P&Z CASE # SP2020-021 **P&Z DATE** 09/15/20 **CC DATE**_____ **APPROVED/DENIED**

Address: 2300 Discovery Blvd. Rockwall, Texas 75032
Subdivision: SWBC Rockwall Addition, Phase II — Lot: 1 — Block: A
General Location: Discovery Blvd. between John King Blvd. & Innovations Drive

RE: SWBC Phase 2 - Site Plan Application
McAdams Job Number WBC 20000

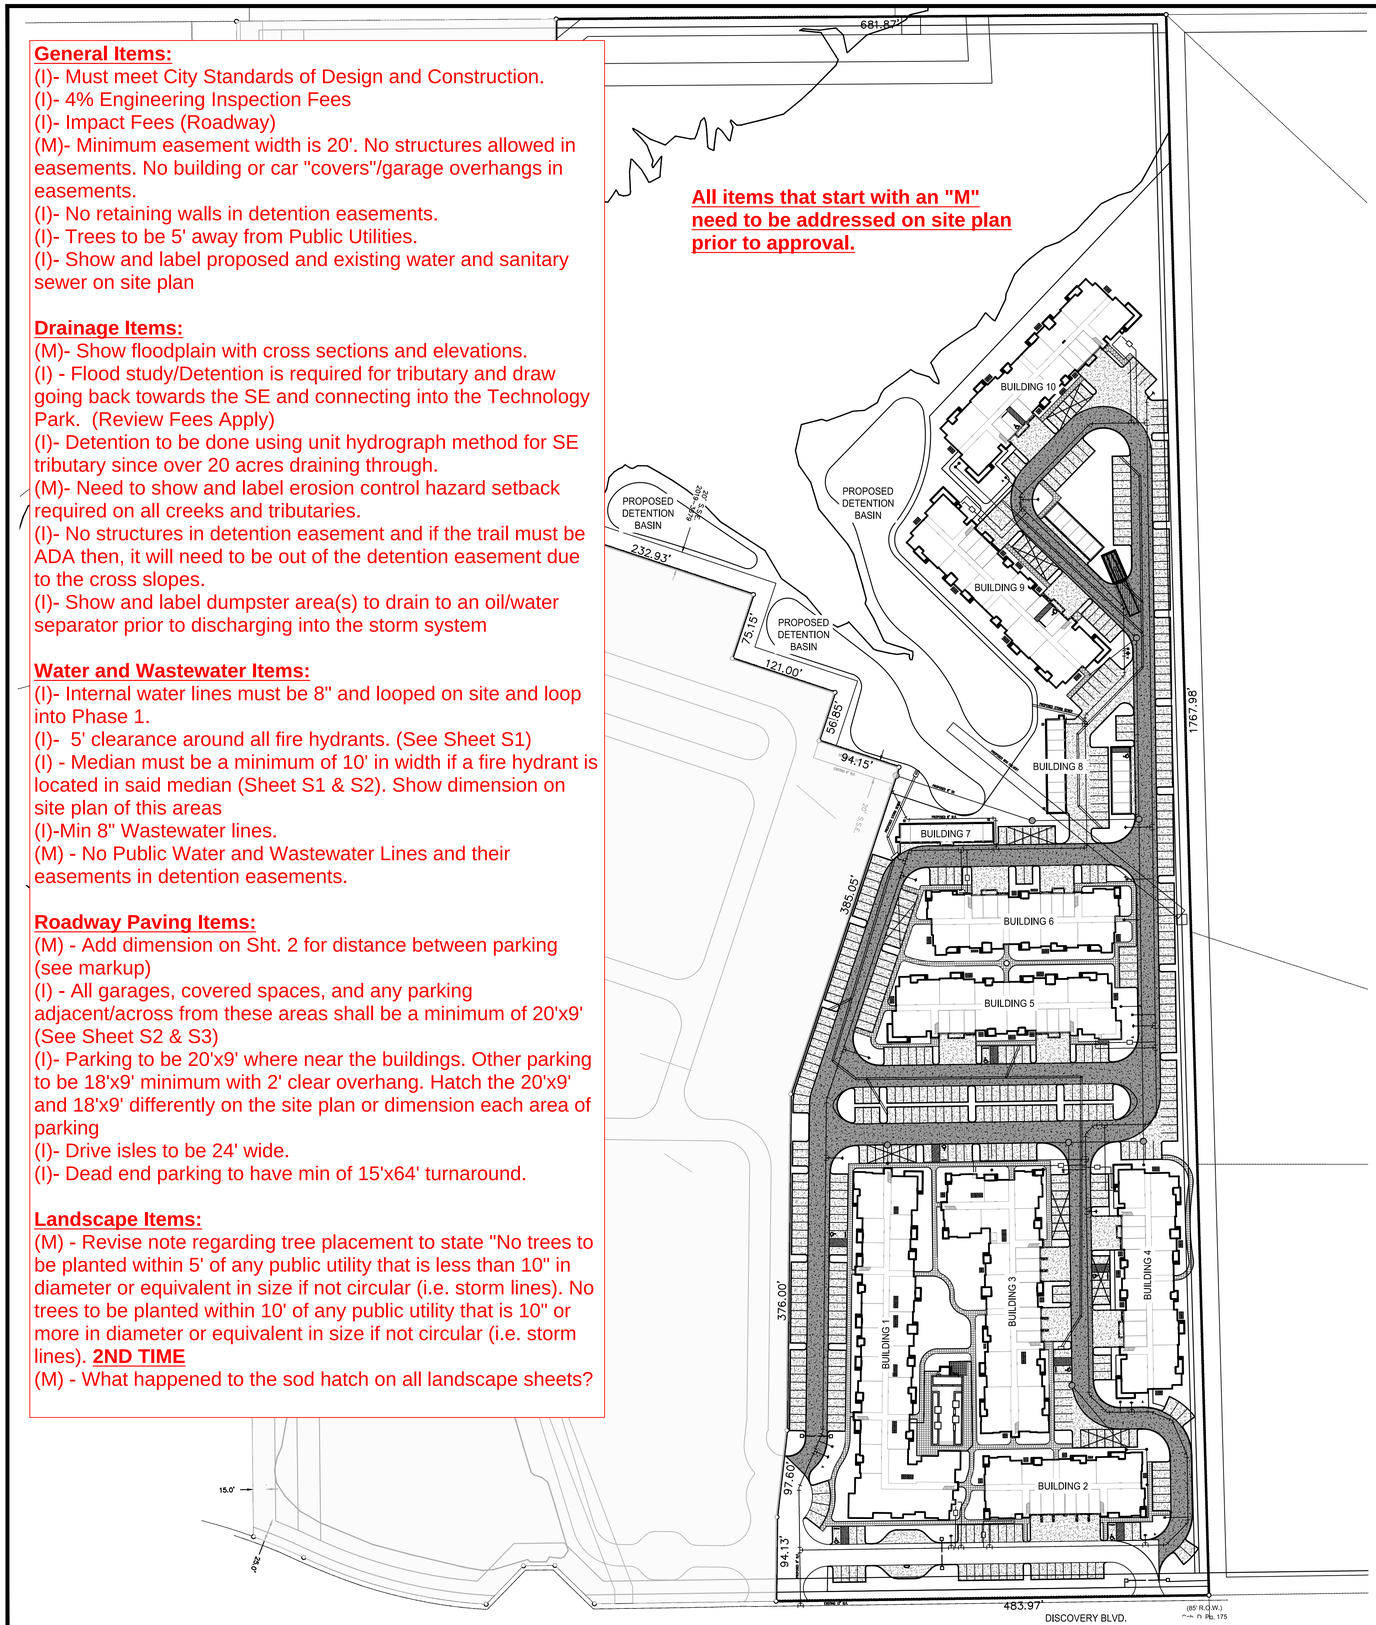
General Items:
(I)- Must meet City Standards of Design and Construction.
(I)- 4% Engineering Inspection Fees
(I)- Impact Fees (Roadway)
(M)- Minimum easement width is 20'. No structures allowed in easements. No building or car "covers"/garage overhangs in easements.
(I)- No retaining walls in detention easements.
(I)- Trees to be 5' away from Public Utilities.
(I)- Show and label proposed and existing water and sanitary sewer on site plan

Drainage Items:
(M)- Show floodplain with cross sections and elevations.
(I) - Flood study/Detention is required for tributary and draw going back towards the SE and connecting into the Technology Park. (Review Fees Apply)
(I)- Detention to be done using unit hydrograph method for SE tributary since over 20 acres draining through.
(M)- Need to show and label erosion control hazard setback required on all creeks and tributaries.
(I)- No structures in detention easement and if the trail must be ADA then, it will need to be out of the detention easement due to the cross slopes.
(I)- Show and label dumpster area(s) to drain to an oil/water separator prior to discharging into the storm system

Water and Wastewater Items:
(I)- Internal water lines must be 8" and looped on site and loop into Phase 1.
(I)- 5' clearance around all fire hydrants. (See Sheet S1)
(I) - Median must be a minimum of 10' in width if a fire hydrant is located in said median (Sheet S1 & S2). Show dimension on site plan of this areas
(I)-Min 8" Wastewater lines.
(M) - No Public Water and Wastewater Lines and their easements in detention easements.

Roadway Paving Items:
(M) - Add dimension on Sht. 2 for distance between parking (see markup)
(I) - All garages, covered spaces, and any parking adjacent/across from these areas shall be a minimum of 20'x9' (See Sheet S2 & S3)
(I)- Parking to be 20'x9' where near the buildings. Other parking to be 18'x9' minimum with 2' clear overhang. Hatch the 20'x9' and 18'x9' differently on the site plan or dimension each area of parking
(I)- Drive isles to be 24' wide.
(I)- Dead end parking to have min of 15'x64' turnaround.
